Tuesday, September 3, 2019
PERMIT MODIFICATION APPROVAL
Horizontal 6A / New Drill

Re: Permit Modification Approval for NUTTER 1208 N-1H
47-033-05940-00-00

Modify surface casing to 1000' to get through coal

RE: Nutter 1208 N-1H thru S-10H Permit Modification Request – (47-033-05940, 5953, 05952, 05954, 05951, 05959, 05960, 05962, 05966 and 05967)
Union District, Harrison County
West Virginia

1208 N-1H
Marcellus Shale Horizontal
Harrison County, WV

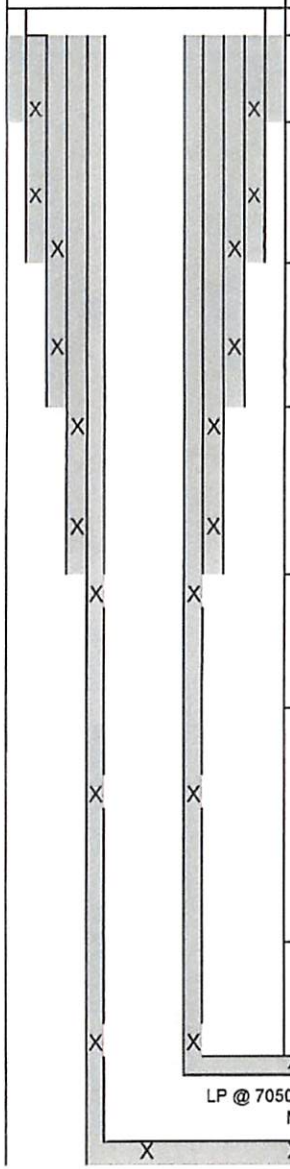
Per discussions with you, enclosed are revised WW-6B's and Well Bore Schematics for all the 1208 laterals, (N-1H – N-5H & S-6H - S-10H). The drilling/engineered plans are revised to extend the fresh water casing, (20"), from the approved 650 feet to 1000 feet; to extend the FW casing beyond the coal seam due to conditions encountered while drilling the 1209 well pad which is in close proximity to the Nutter 1208 well pad.

HOLE	CASING	GEOLOGY	TOP	BASE	MUD	CEMENT	CENTRALIZERS	CONDITIONING	COMMENTS
30"	30" 157.5# LS	Conductor	0	120	AIR	N/A, Casing to be drilled in w/ Dual Rotary Rig	N/A	Ensure the hole is clean at TD.	Conductor casing = 0.5" wall thickness
24"	20" 94# J-55	Fresh Water	0	135	AIR	15.6 ppg PNE-1 + 3% bwoc CaCl 40% Excess Yield=1.20 / CTS	Centralized every 3 joints to surface	Once casing is at setting depth, circulate a minimum of one hole volume with Fresh Water prior to pumping cement.	Surface casing = 0.438" wall thickness Burst=2110 psi
		Kittaning Coal	810	815					
		Coal/Fresh Water	0	1000

Per our discussion earlier today, I am okay with the fresh water casing modification to 1,000'.
